TECHNICAL BULLETIN

505-18-10

MODEL AFFECTED: 505

SUBJECT: DOOR LOCK RETROFIT KIT

FIGURE 1 – Crew door lock retrofit (Sheet 6 of 10)

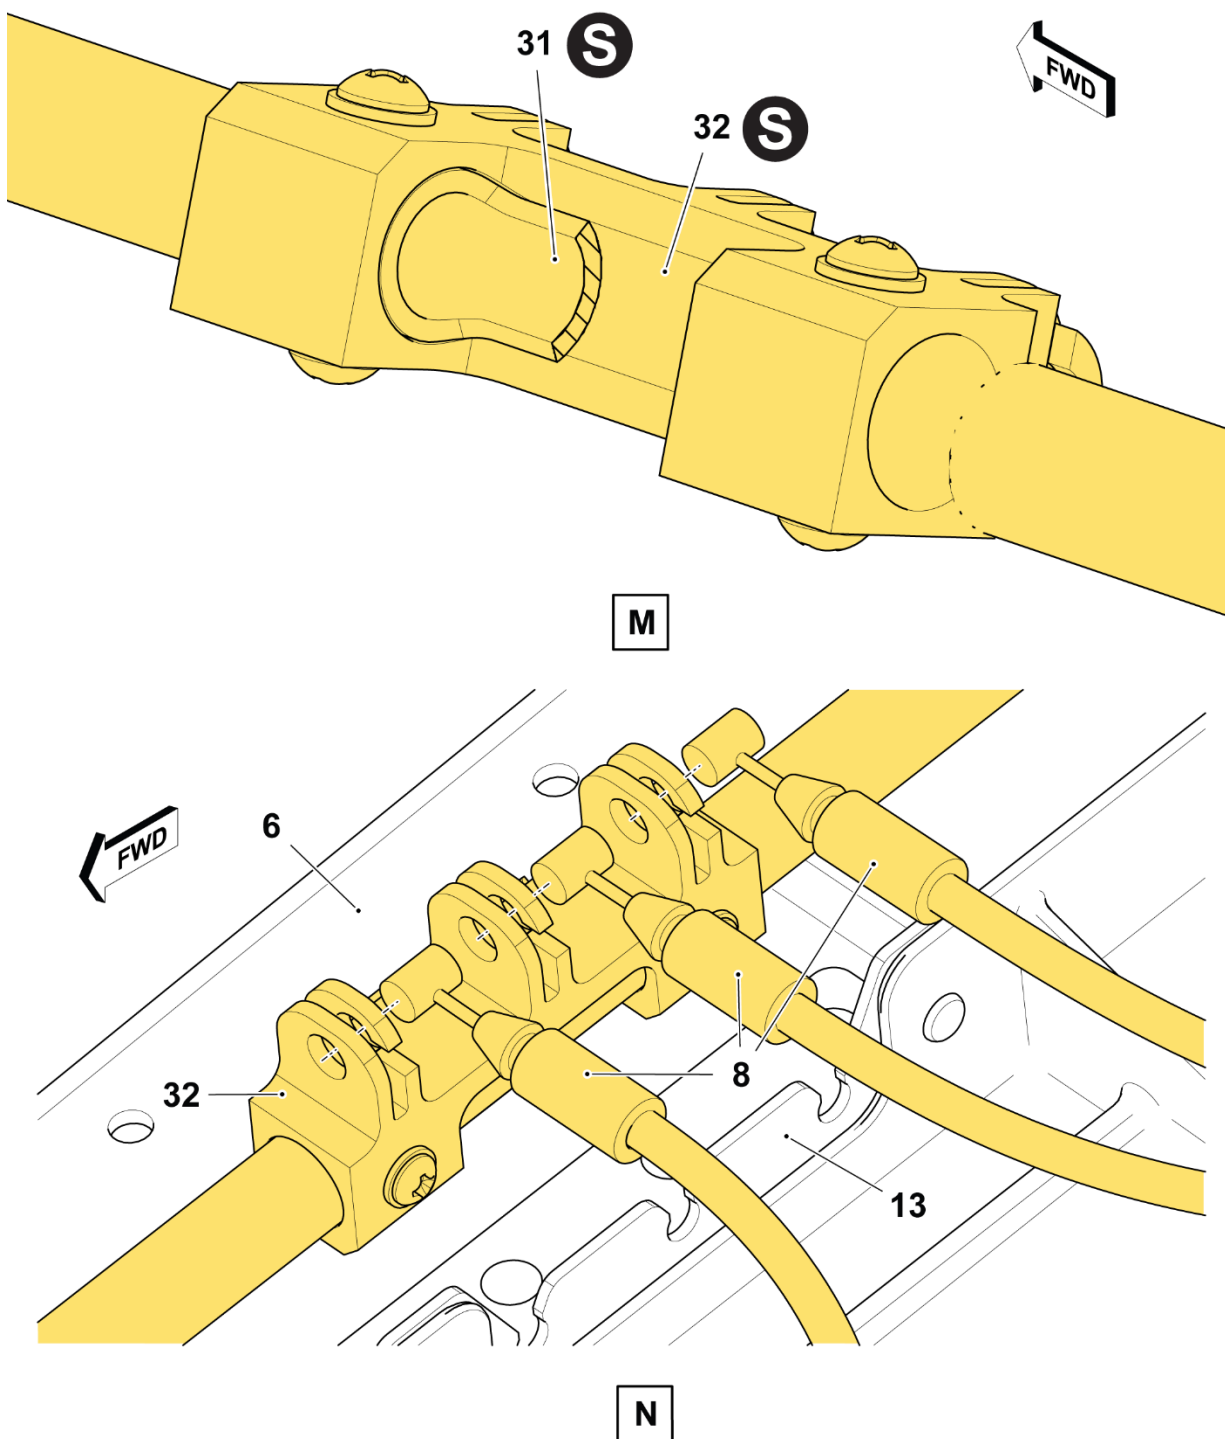
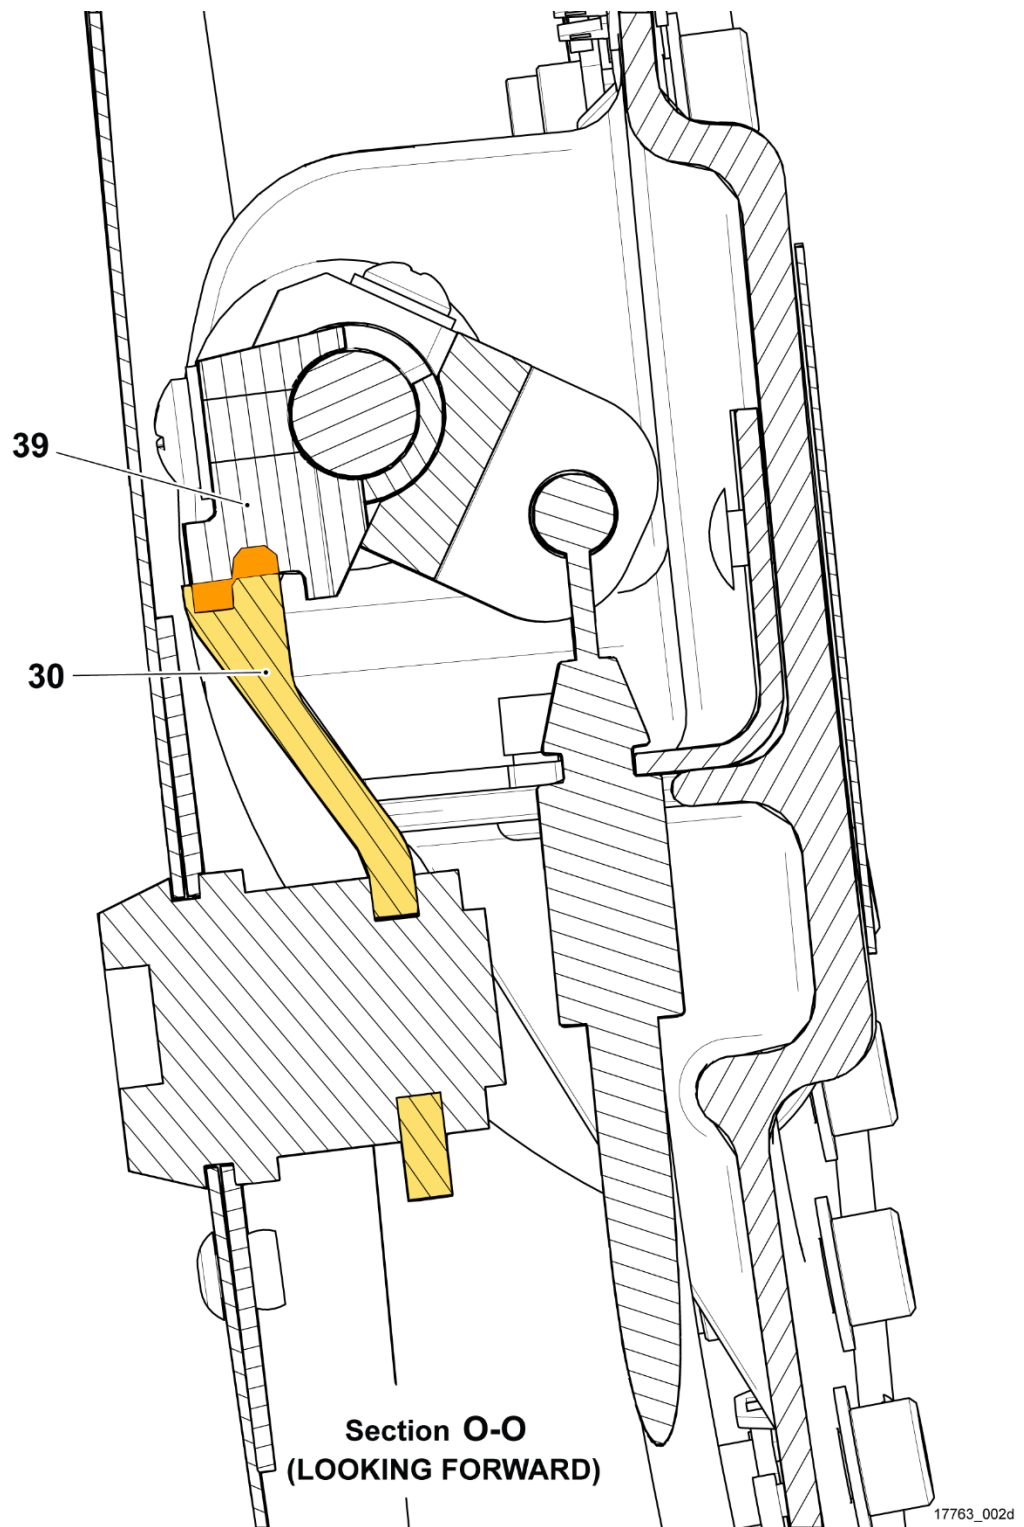
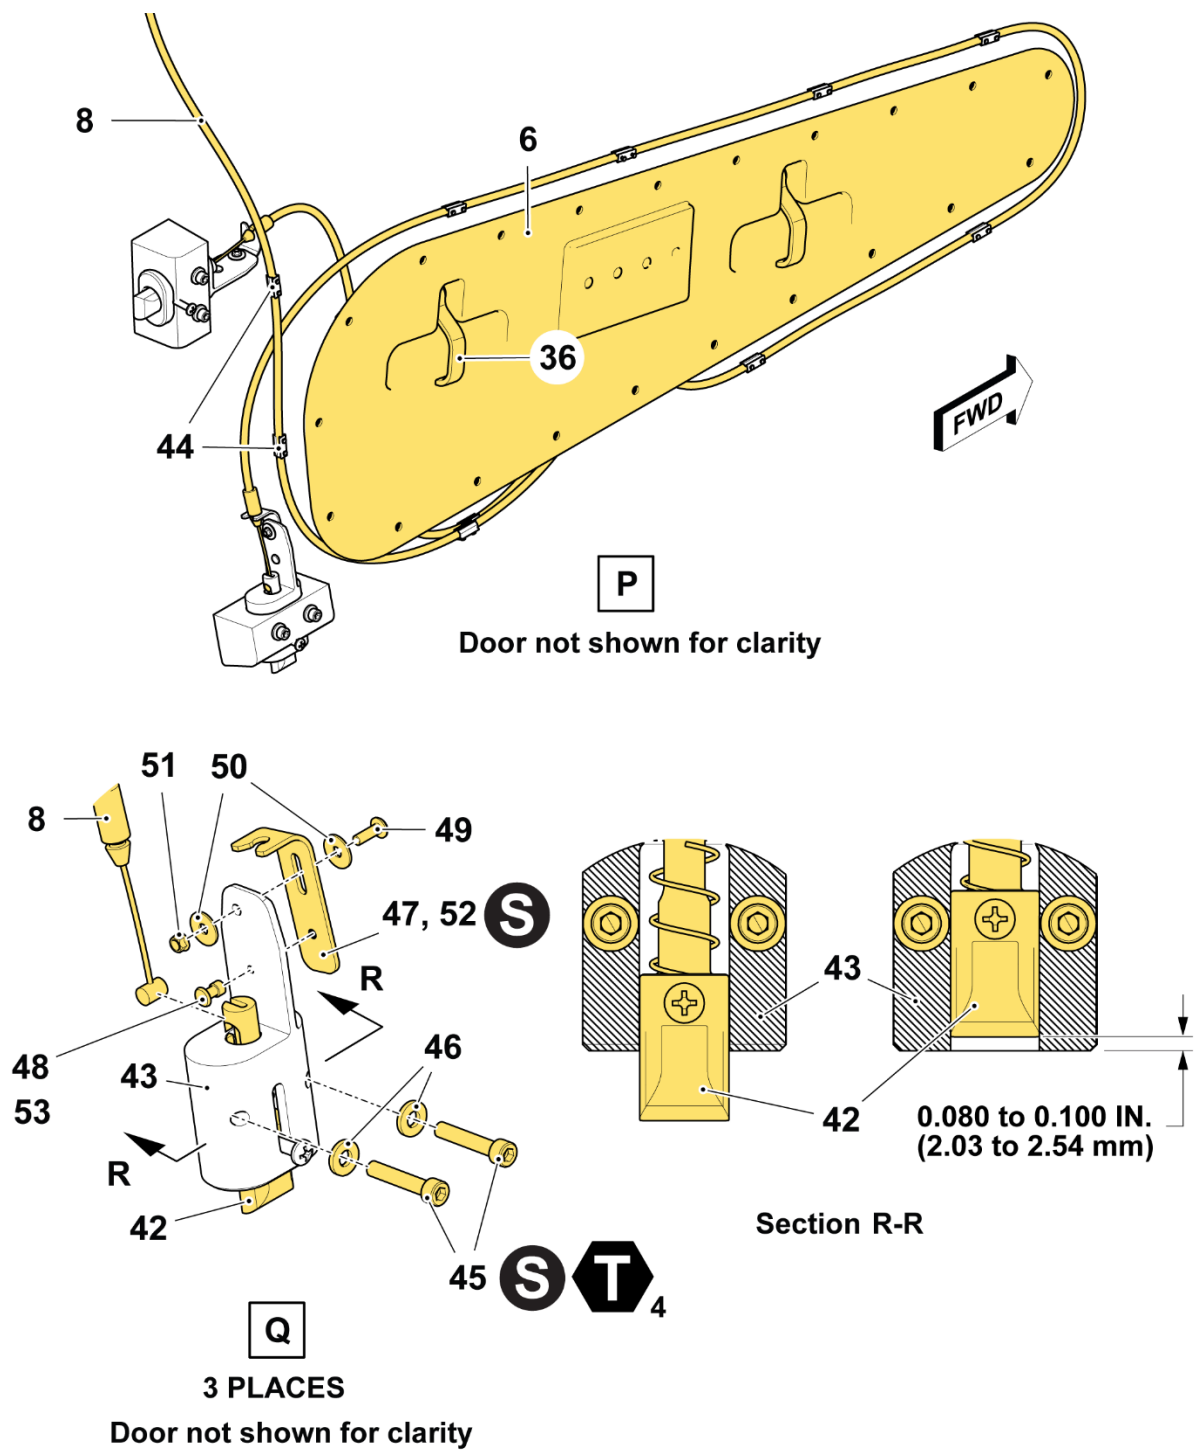
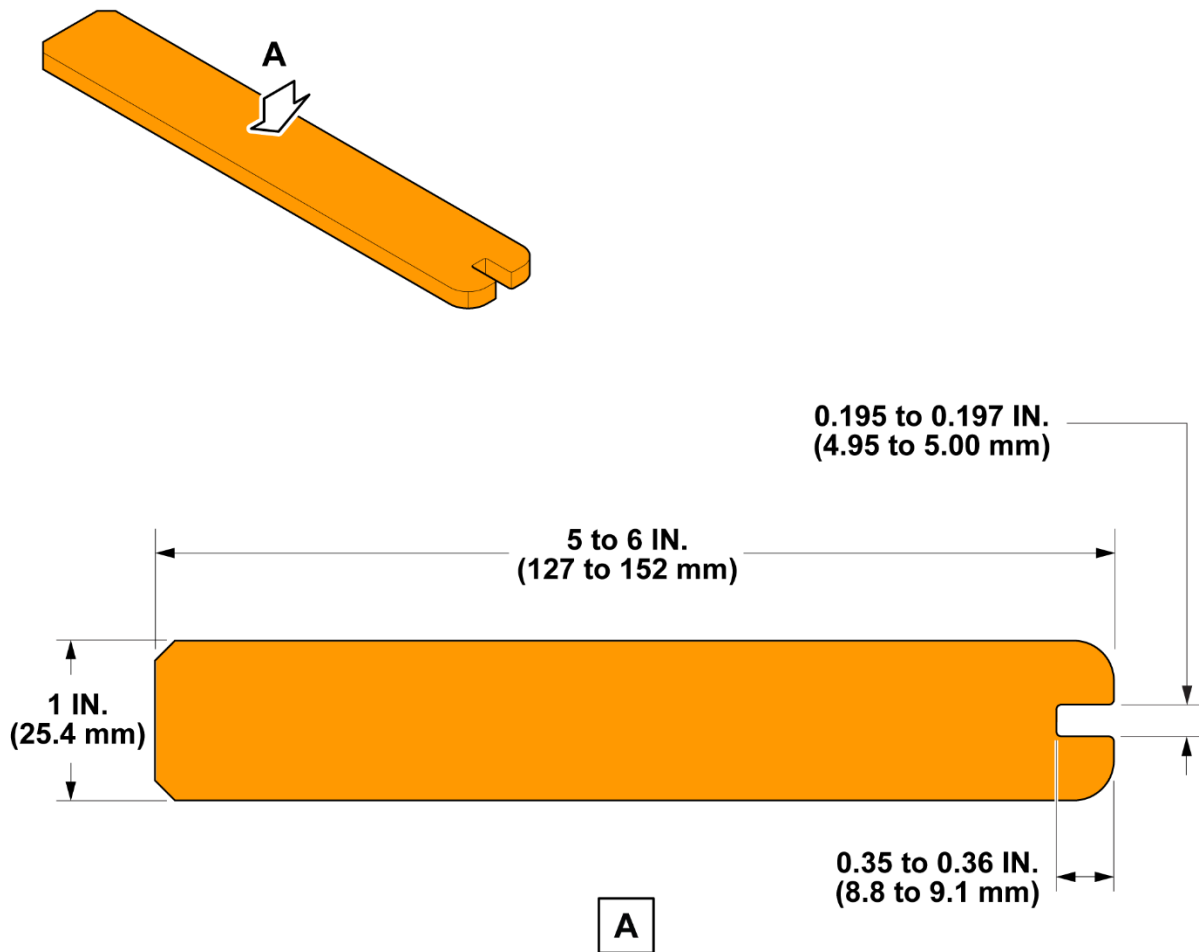
This Technical Bulletin provides instructions to retrofit cabin doors SLS-030-110-001/-002 with latest production door locks. The change offers a door opening mechanism that can be opened from the inside when locked. Applicability of this bulletin to any spare part shall be determined prior to its installation on an affected helicopter.

- a. If the currently installed doubler resembles item 23 in detail H, proceed to step 15.
- b. If the currently installed doubler resembles item 24 which has a flat portion on the top, disregard steps 15 to 18 and continue from step 19 onward.

The doubler (24) SLS-030-110-267 is to be installed with the flat section facing up.

Opening on the lock assembly (29) for the pin on the cam (30) must be on the bottom when installed.

The end of the outer actuator rod (31, View J) which has cotter pin holes must be directed FWD when installed on the inner door panel (6).

The cable insertion hole of the actuator fitting (32, View N) must be directed inboard when installed.

The door lock mechanism is designed to induce a positive pressure from the cam (30, Section O-O) onto the lock fitting (39) when placed in the locked position to prevent movement of the exterior handle (2, View A).

- a. Verify each latch bolt (42, Section R-R) recesses 0.080 to 0.100 inch (2.03 to 2.54 mm) inside the latch housing (43) by operating interior handle (36, View P) and exterior handle (2, View A) individually to their full unlatched position.
